Subject: **WATTS BAR NUCLEAR PLANT (WBN) UNIT 2 - RESPONSE TO
LARGE BREAK LOSS OF COOLANT ACCIDENT (LBLOCA) AND
OVER-PRESSURIZATION REQUEST FOR ADDITIONAL
INFORMATION**

Watts Bar Unit 2 (WBT) Responses to Request for Additional Information (RAI) – BE LOCA Data for Transmittal to NRC

**WATTS BAR NUCLEAR PLANT UNIT 2
WATTS BAR UNIT 2 LOSS OF LOAD RESULTS
WITH NO CREDIT FOR THE FIRST SAFETY GRADE TRIP**

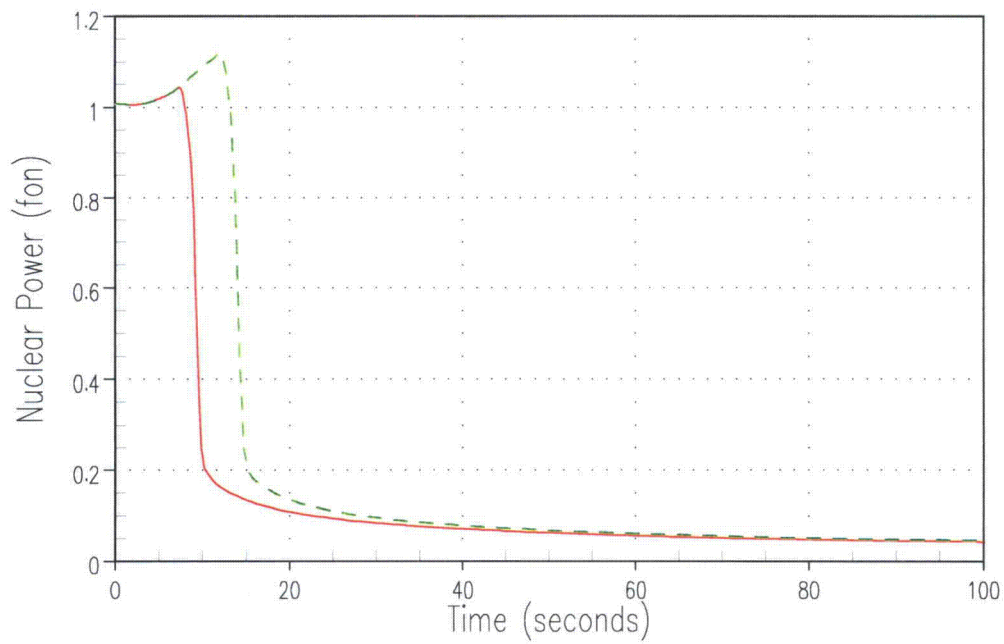
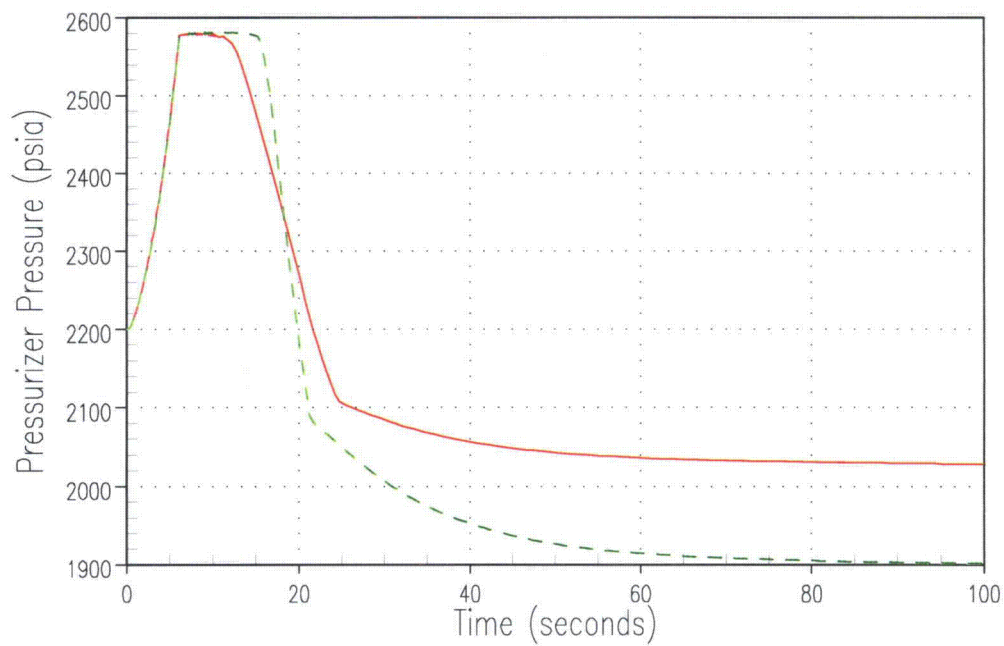
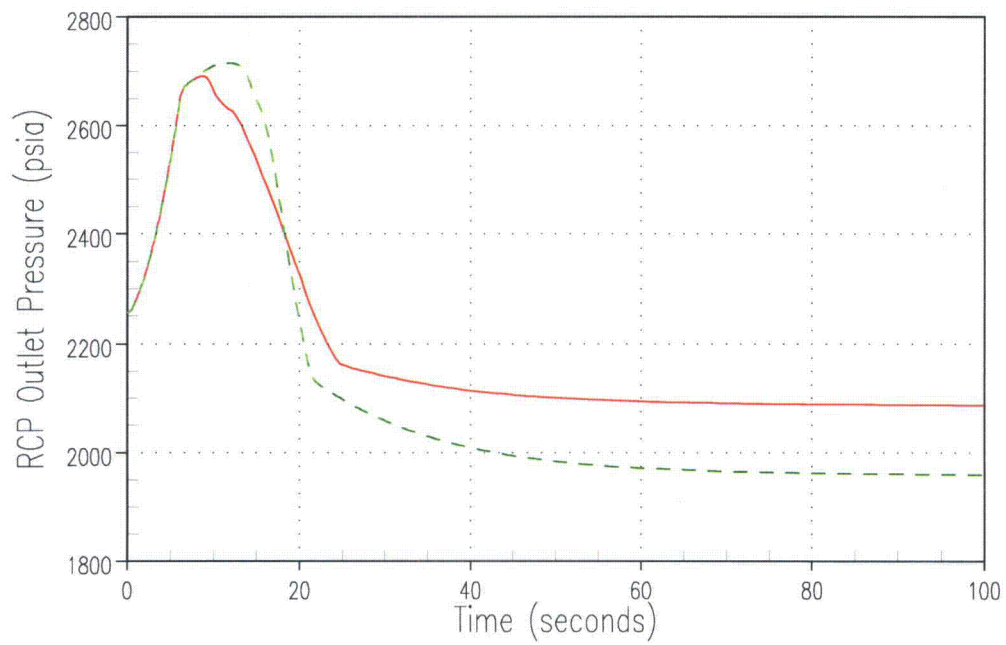
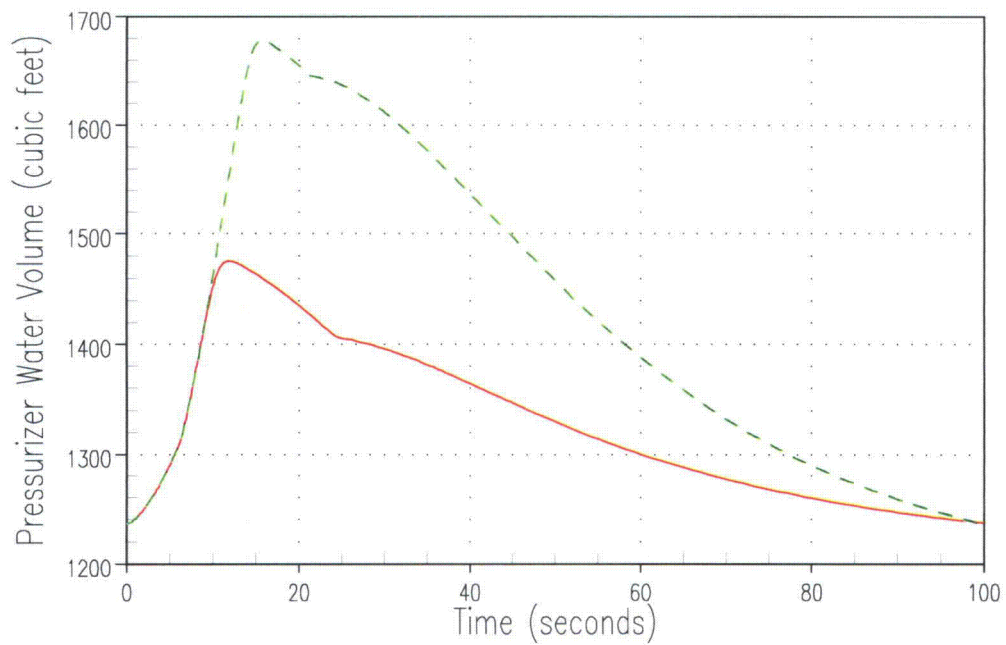
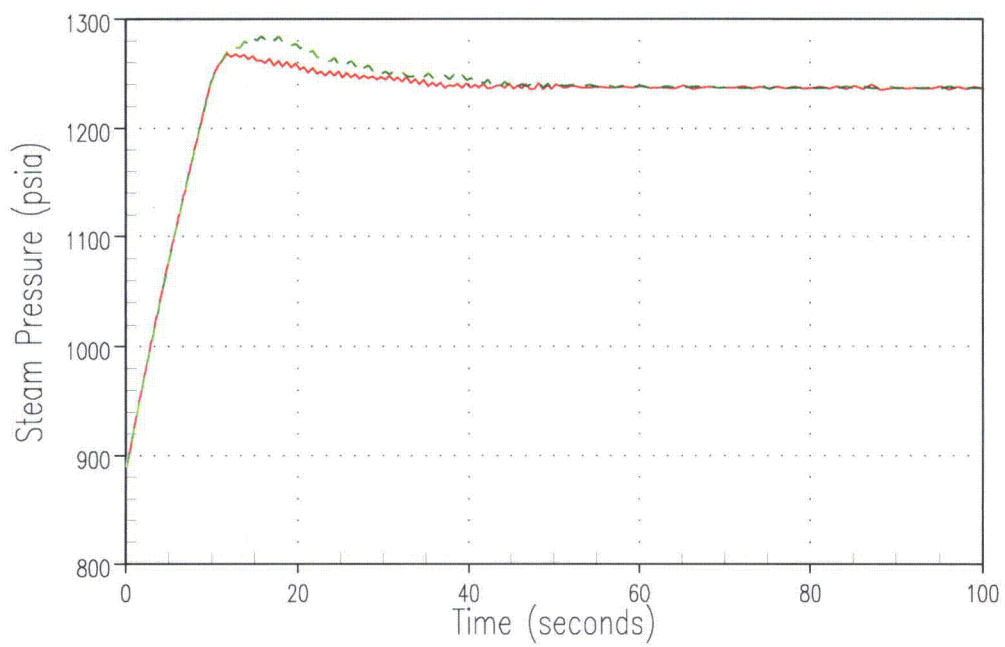
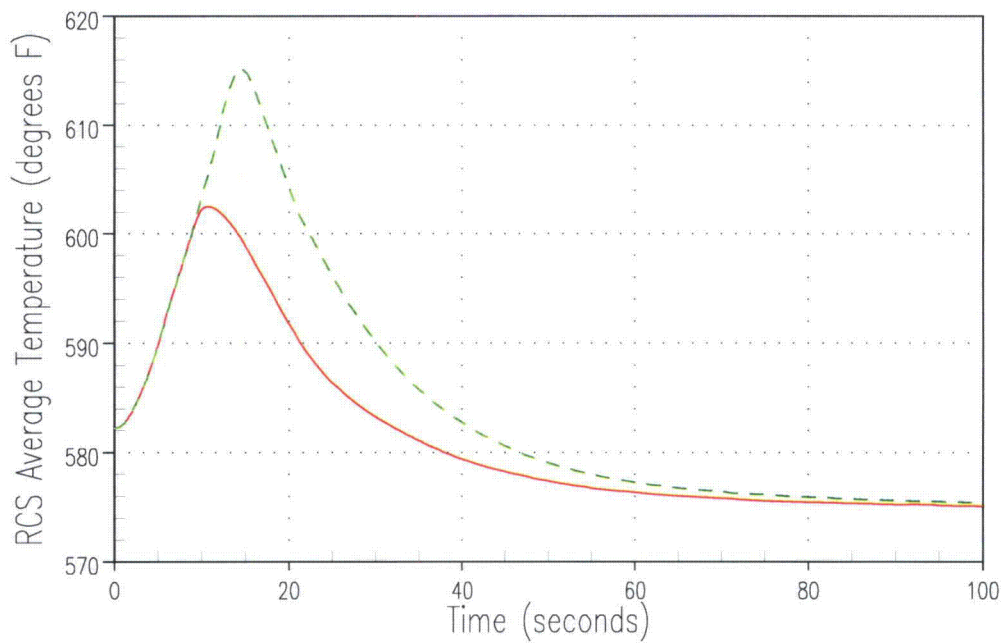
The Nuclear Regulatory Commission (NRC) has requested the results of an additional Loss of Load analysis with no credit taken for the first safety grade trip reached. In the licensing basis Loss of Load analysis for Watts Bar Unit 2, the first safety grade trip reached is the High Pressurizer Pressure trip. A new analysis with no credit taken for reactor trip via High Pressurizer Pressure has been run. This new analysis contains all the same conservative assumptions as the FSAR analysis. No best-estimate or better-estimate assumptions were made. Sequence of events for the two cases are provided below:

With credit for the first reactor trip function (high pressurizer pressure), the peak primary system pressure reached is 2691.8 psia with rod motion via high pressurizer pressure reactor trip function occurring at 6.76 seconds. Reactor trip on overtemperature ΔT occurs 4.5 seconds later than the high pressurizer pressure trip occurs in the FSAR case and the new peak primary system pressure is 2714.7 psia. Thus, even with no credit for the first trip and all other analysis assumptions unchanged, the peak primary pressure does not exceed 110% of the design pressure.

The following transient plots show the key parameters for the two cases analyzed. The solid red lines represent the analysis with credit for the high pressurizer pressure trip and the green dashed lines represent the case without credit for the high pressurizer pressure reactor trip function.
